Change Order Request

PFAS Well 15

Field Order 11- Curb at Generator Area

FO#11

SK-4 DRAWING
RESPONSE TO RFI #35

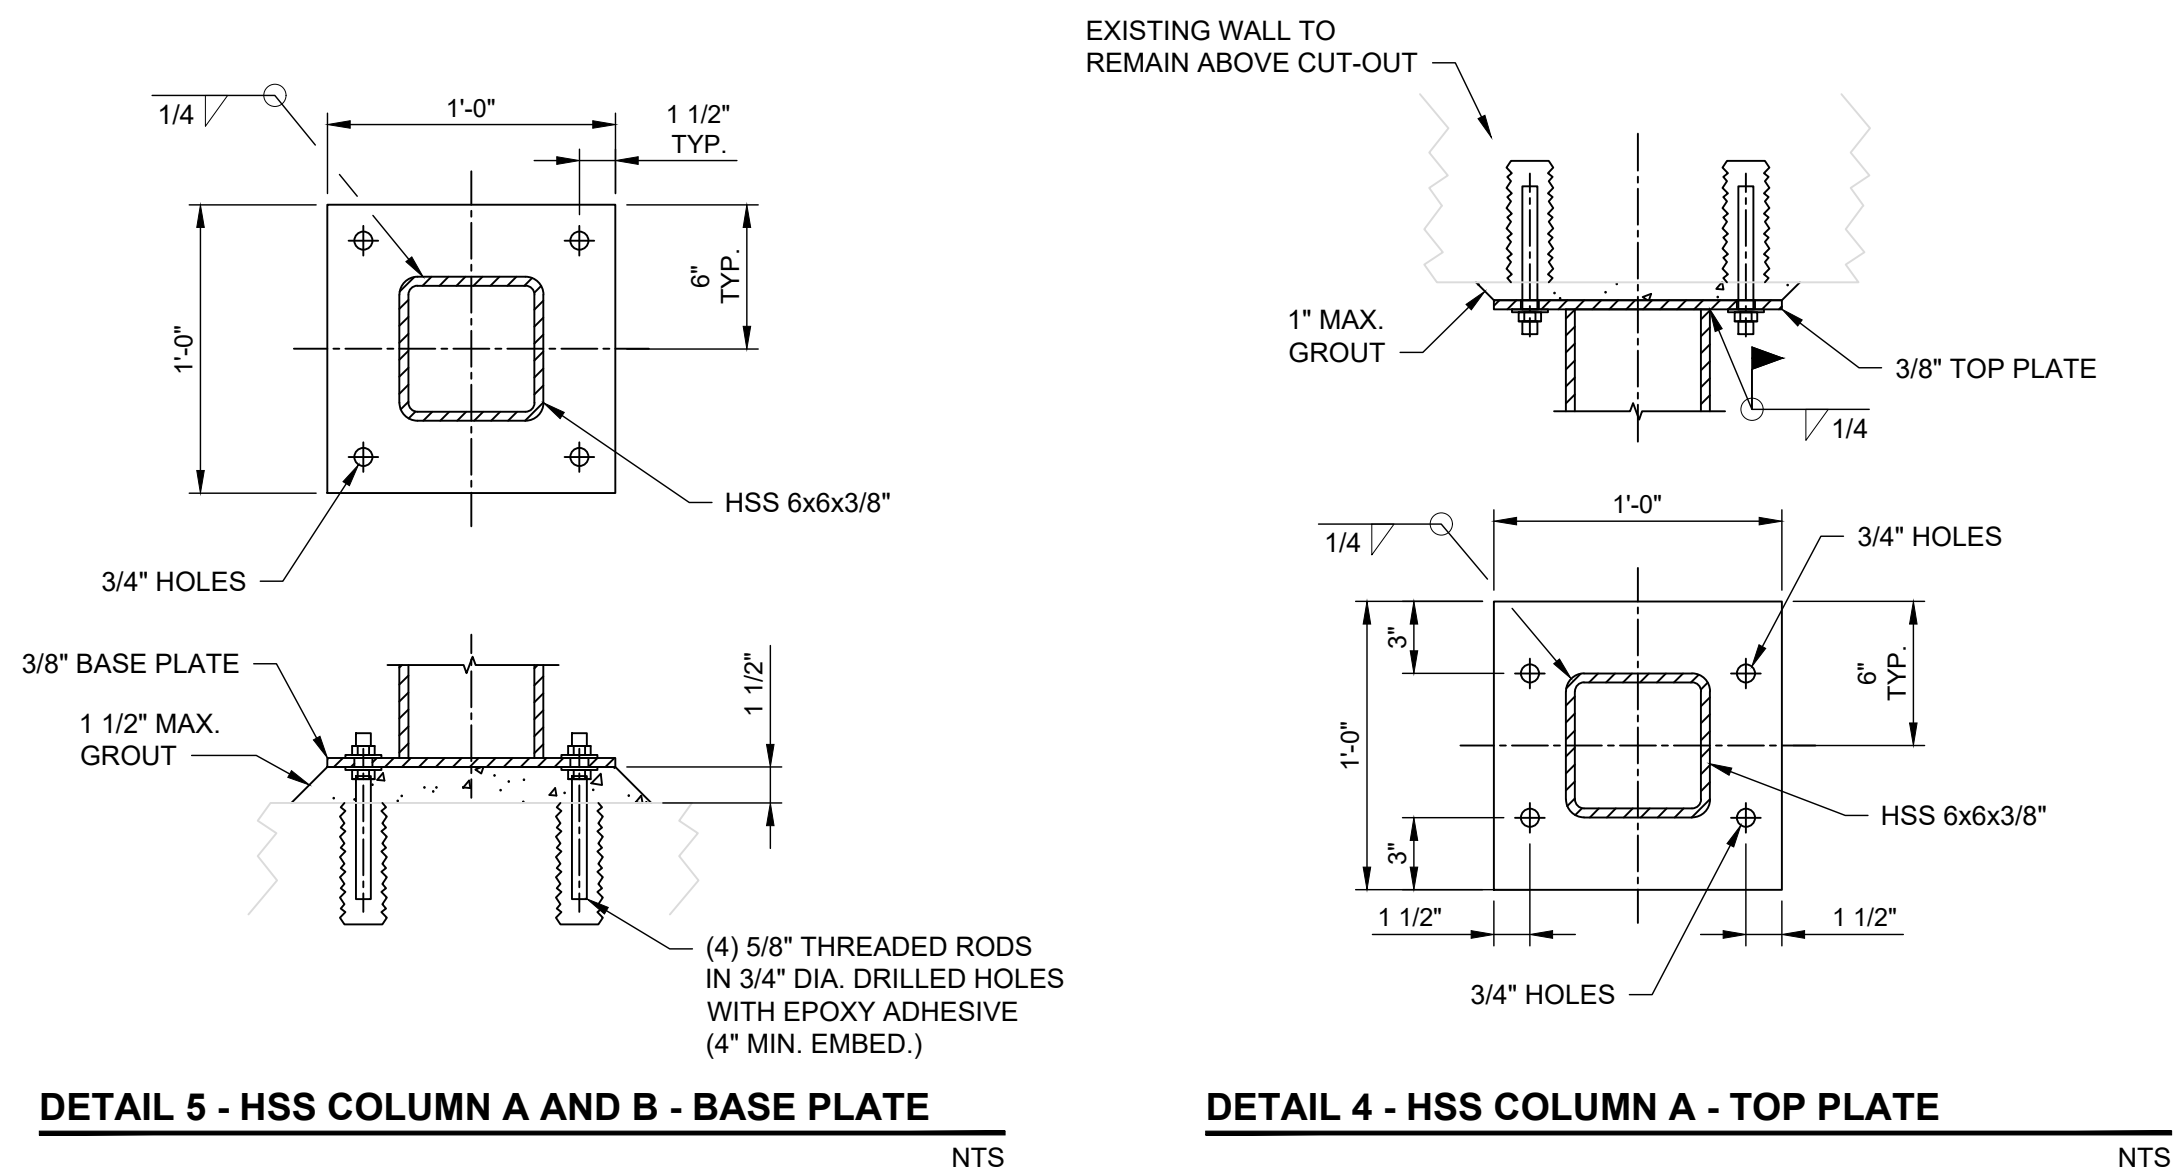
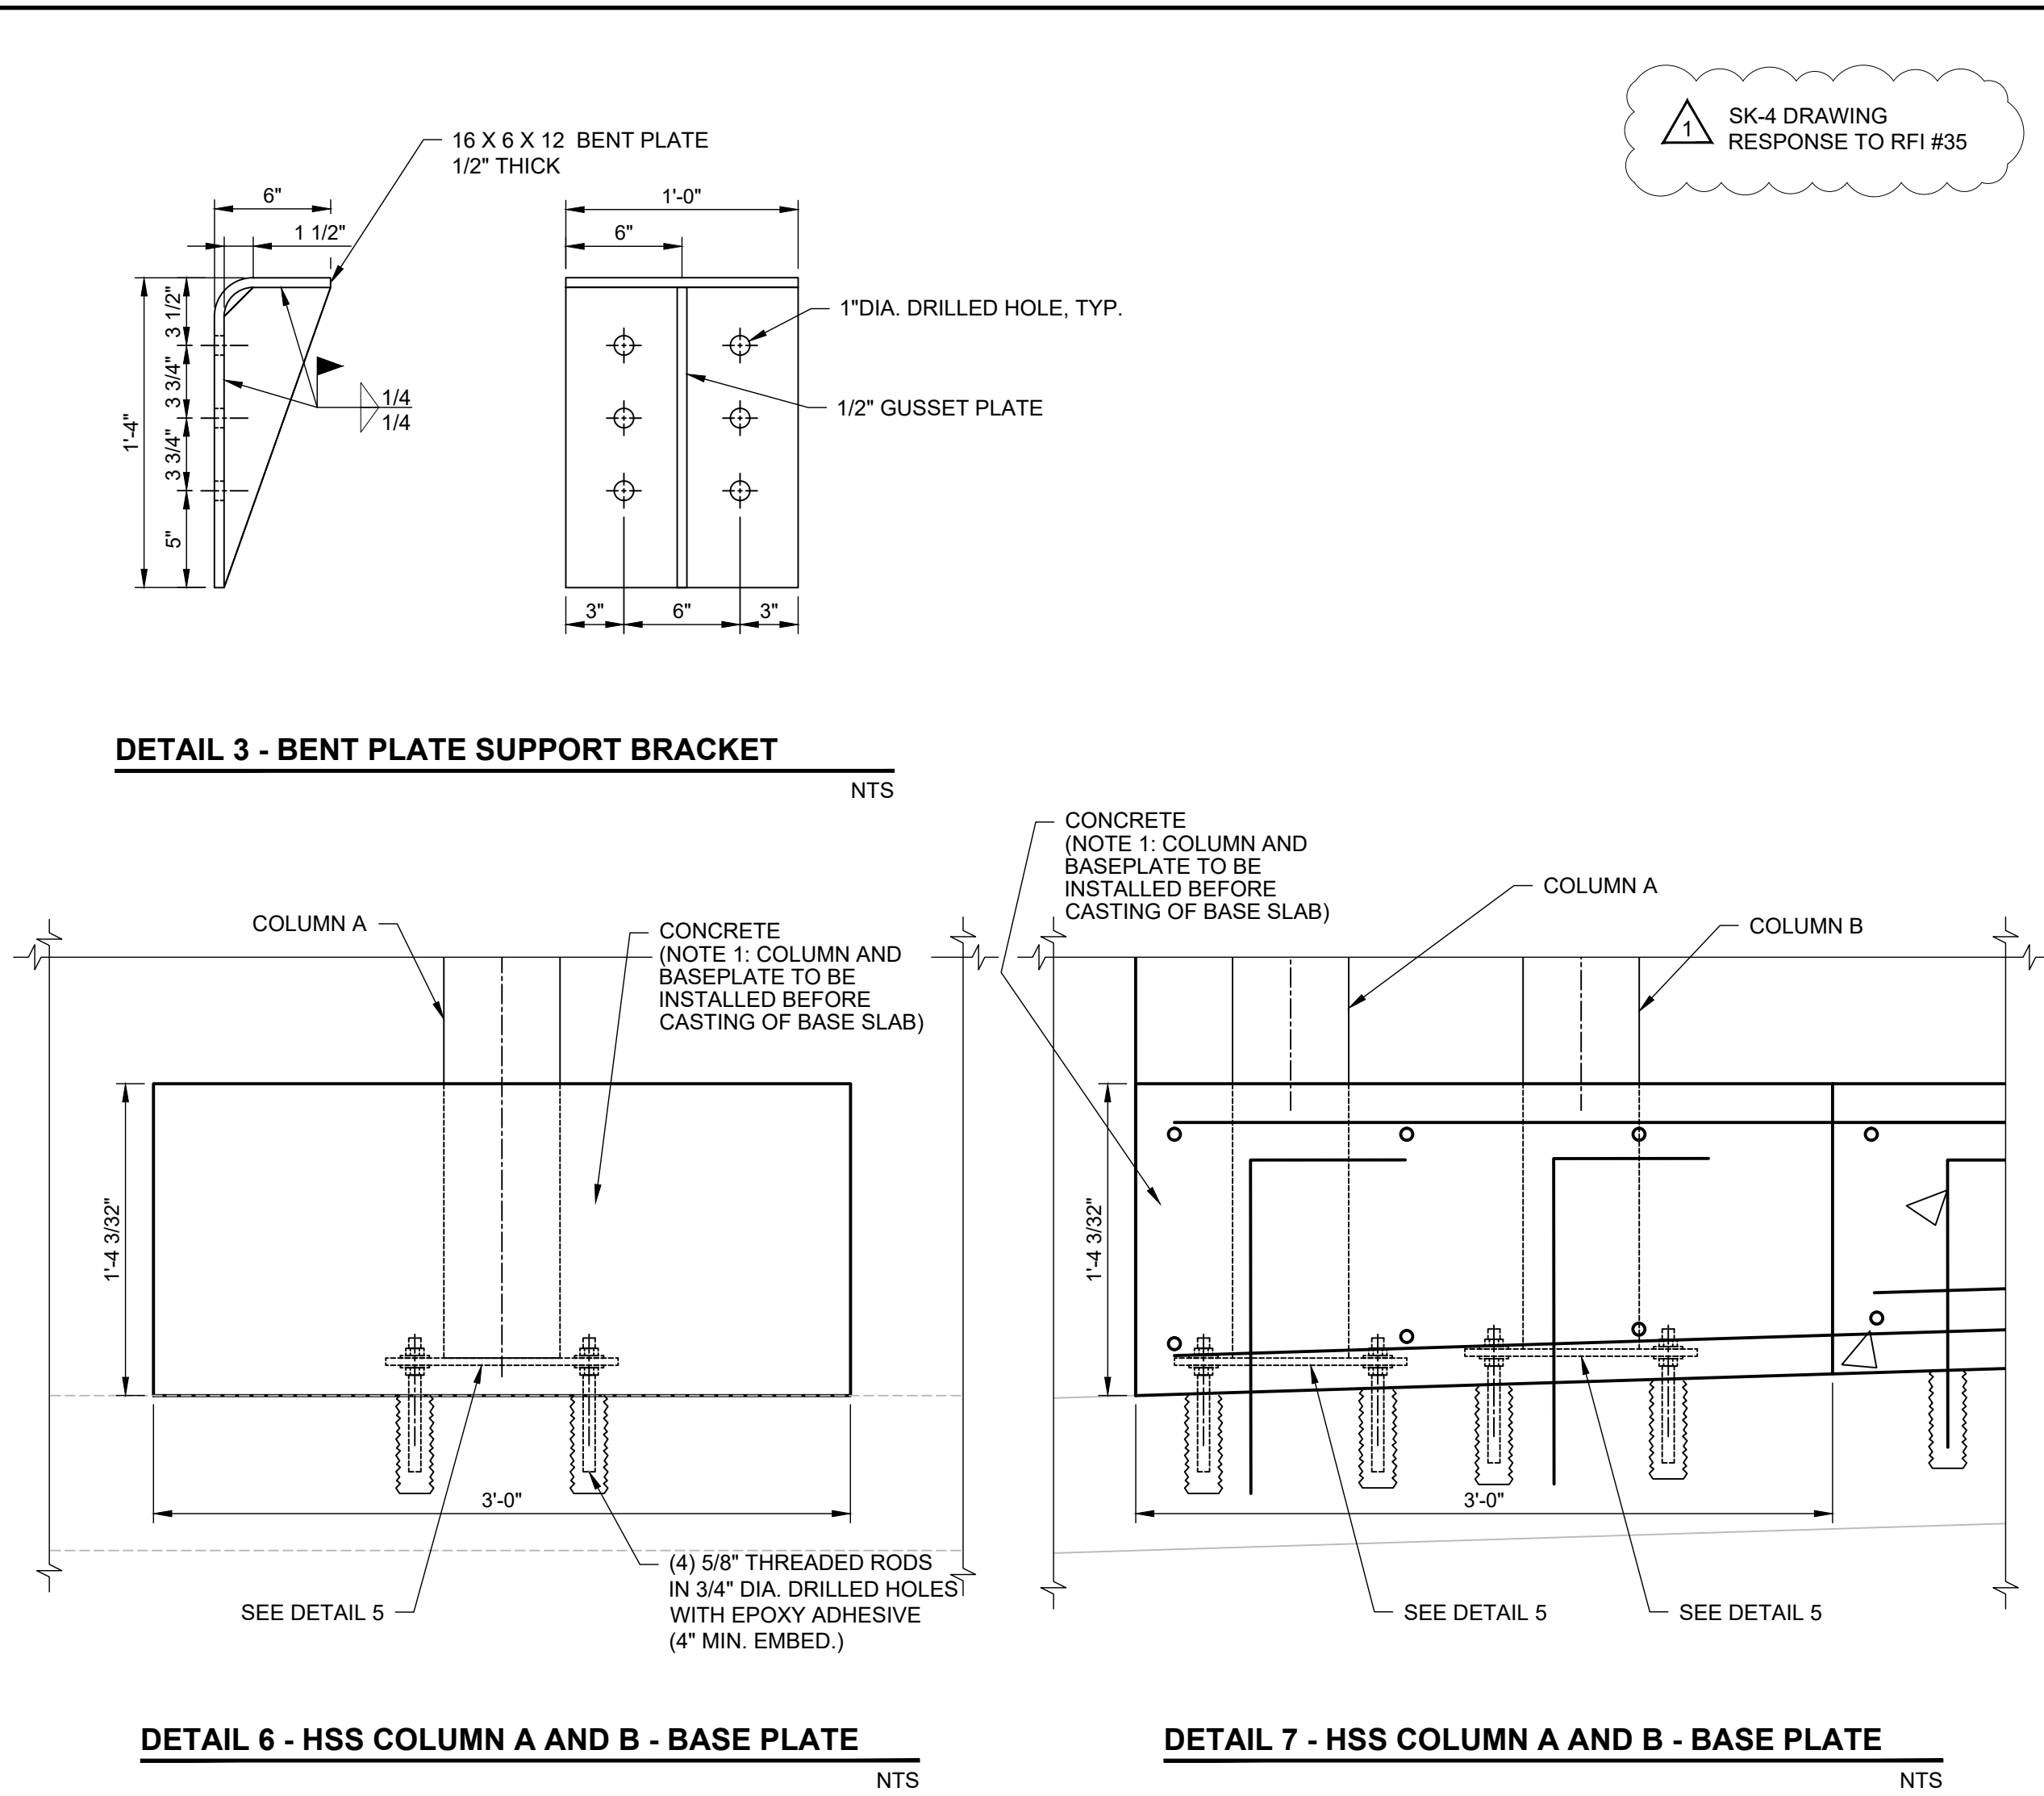
ISSUE/REVISION		
1	10/21/2024	RESPONSE TO RFI #35
I/R	DATE	DESCRIPTION

1. The existing 5 to 6-inch deep sawcuts at the two locations are to be cleaned out and filled with epoxy by gravity feed with resin method in accordance with the manufacturer's recommended installation procedures.
 - a. Reference: American Concrete Institute's' ACI RAP Bulletin 2 – Field Guide to Concrete Repair Application Procedures, Crack Repair by Gravity Feed with Resin.
 - b. Epoxy material shall be Sikadur-32 Hi-Mod manufactured by Sika Corporation or engineer's approved equivalent.
2. Install steel columns as shown on the attached revised drawing Nos. 10-S-01 and 10-S-08, dated 10/21/24 and Sketch SK-4 dated 10/21/2024 to support existing slab and beam floor system. SK-4 will be incorporated into the As-Built drawings when project is completed.
3. Provide cost and schedule impacts, if any, for this work to AECOM and Owner for review prior to commencement of work.
